**CONTRACT DOCUMENTS
BOONE COUNTY, MISSOURI
BID NO: 45-14JUL05 – Lake of the Woods**

ADDENDUM #1
(Issued July 8, 2005)

LAKE OF THE WOODS PAVEMENT AND DRAINAGE IMPROVEMENTS - PHASE I

ADDENDUM #1

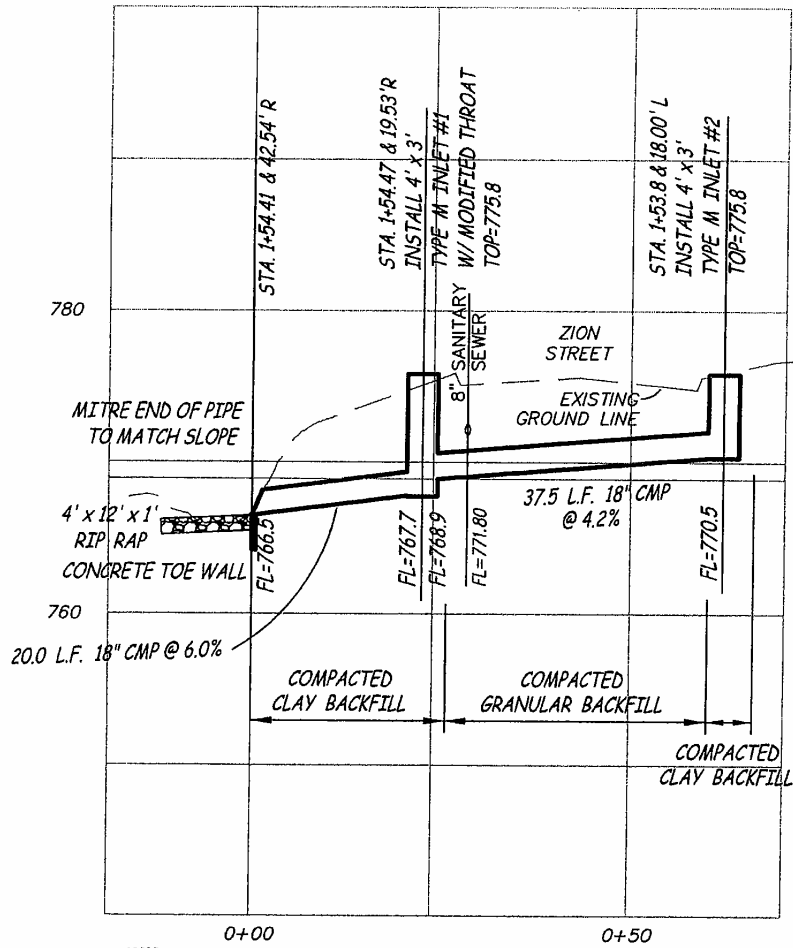
3. Pipe Material Change: The Ultra FLO smooth wall aluminized steel pipe shown on sheet 4 of the plans has been replaced with Polymeric coated corrugated metal pipe (CMP) in accordance with Section 260 of the *Boone County, Missouri, Roadway Regulations*. See attached pipe flowline revision drawings.
